Planning Report

NE Quad, Subarea 3 – Hawthorne Commons

Agenda Item	2
Case Number	15-118FDP
Proposal	A development of 86 multiple-family units for an approximately 13-acre, vacant and all associated site improvements.
Request	Review and approval of a final development plan under the provisions of Code Section 153.050.
Site Location	West of Wyandotte Woods Boulevard, 1,000 feet north of the intersection with Emerald Parkway within Subarea 3 of the Northeast Quadrant Planned Unit Development District.
Owner	Homewood Corporation
Applicant	Treplus Communities; Glen Dugger, Smith and Hale
Case Manager	Jennifer Rauch, AICP, Planning Manager (614) 410-4690 jrauch@dublin.oh.us
Planning Recommendation	<u>Approval of Minor Text Modification</u> Planning supports the minor modifications as it meets the review criteria.

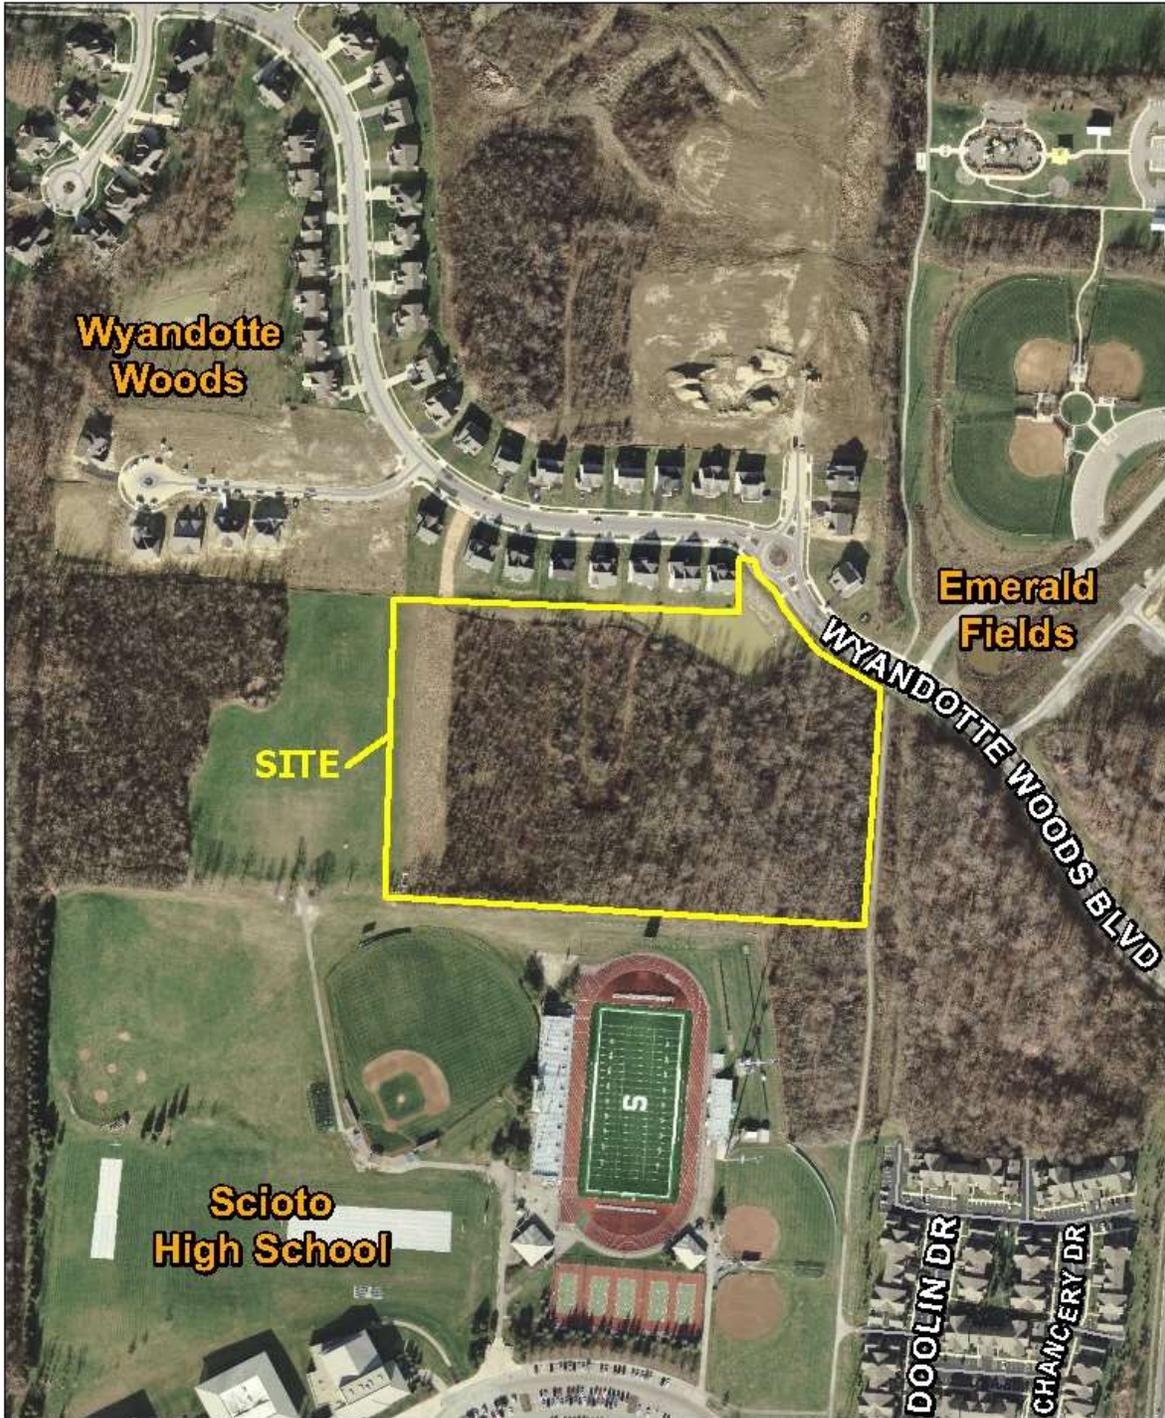
To modify the development text to allow the buildings to encroach as follows:

- 14.4 feet maximum into the 35-foot required front yard (north)
- 16.3 feet maximum into the 25-foot required rear yard (south)
- 10.1 feet maximum into the 25-foot required side yard (east)
- 14.7 feet maximum into the 25-foot required side yard (west)
